March 20, 2024

Austin Environmental Commission
Via Electronic Delivery

Re: Southshore District Combining District and Density Bonus

Figure 3.2: SCW Subdistrict and Floor-to-Area Ratio Map

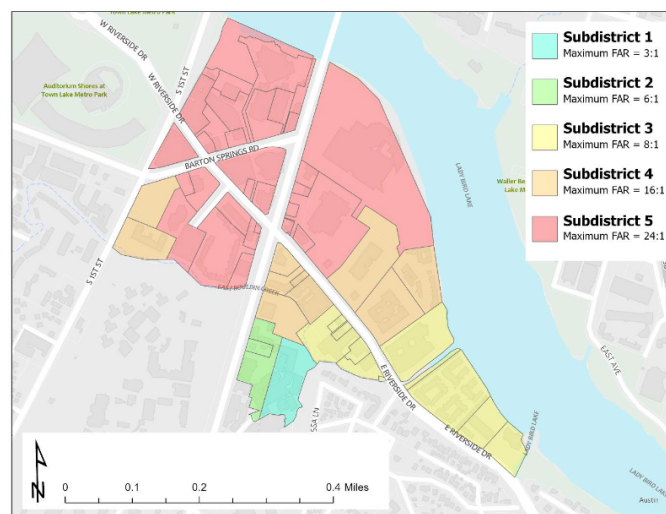
4. Scale back on Downtown Level Densities

24:1 FAR would put some of the largest towers in Austin along the South Shore (now characterized by trees). For comparison, DMU (Downtown Mixed Use) a long-standing zoning category for areas of Downtown Austin had an FAR of 8:1. Subdistrict 5, which is the predominant subdistrict within the proposed plan would triple that downtown level density.
